Submission No 104

From: Claus Oustrup, Scangroup Pty Ltd
Re: AS 1428-1 draft of 02/02/09

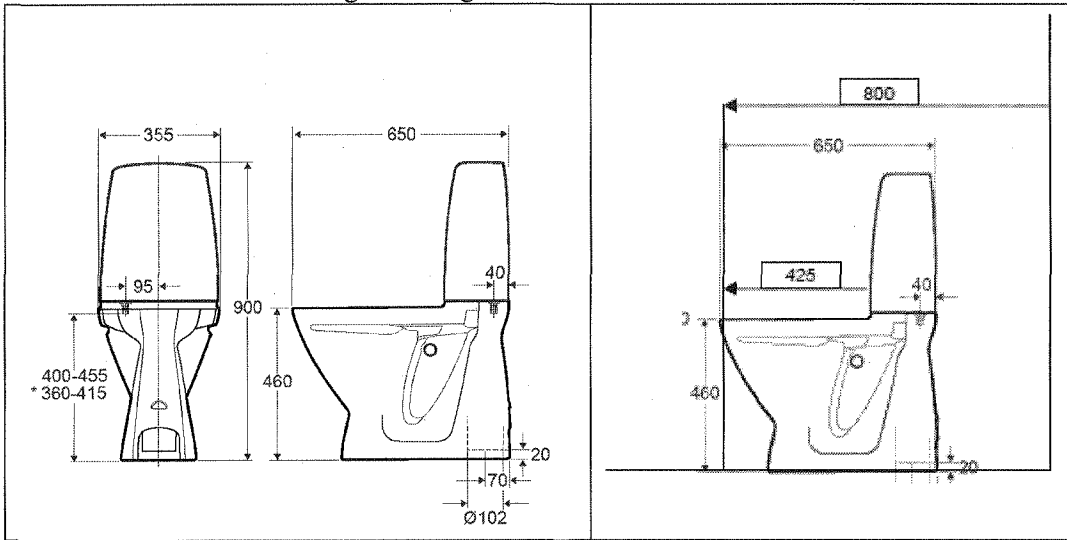
Height of back rest:

The current draft specifies the back rest to be between 150-200 mm high. There should be only a minimum depth and not a maximum.

If the back rest is more than 200 mm it will only give added support and increase the assistance.

Ifo Care 6861 increased height WC figure 1:

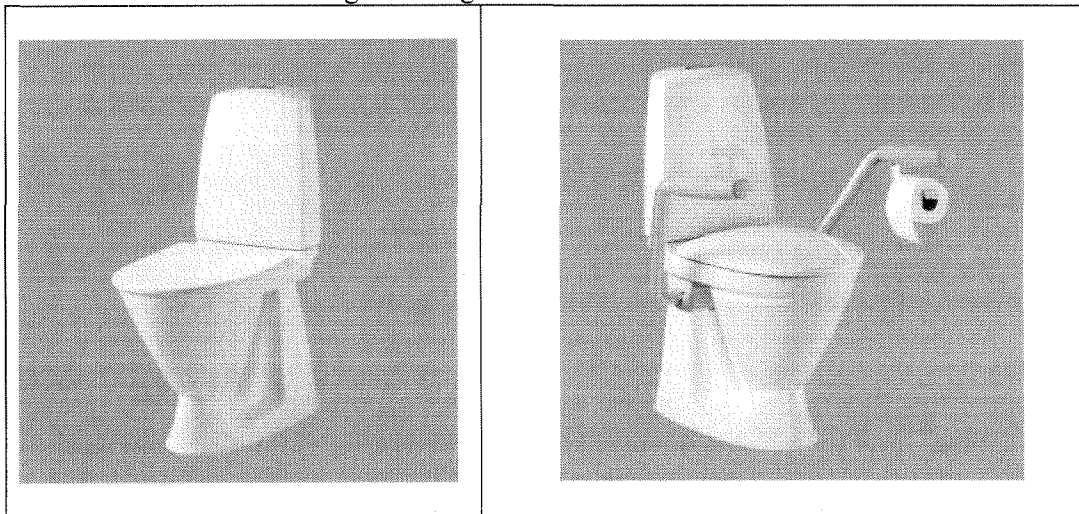
As a reference please find the measurements of our increased height WC, which we believe would be ideal and suit a modified AS 1428:
